Illustrated Parts List - IPL Update

H560XP/XPG

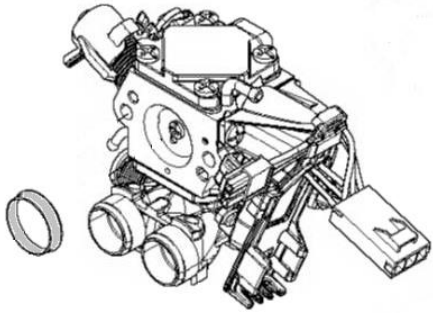
1. New Inlet pipe, assy 583 96 41-03/-04 have been introduced. The change has been made to ensure the assembly and to avoid leakage.
2. The New Carburetor, kit 501 46 33-05 consist of: New Carburetor ZAMA140058A, a separate support sleeve 582 02 51-01 and AT-instruction.
3. New article number and some minor changes on Air Nozzle due to change of supplier.

1. Carburetor

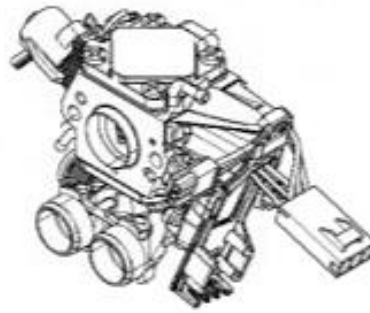
New version

501 46 33-05, ZAMA140058A

Old version

501 46 33-03, ZAMA140055A
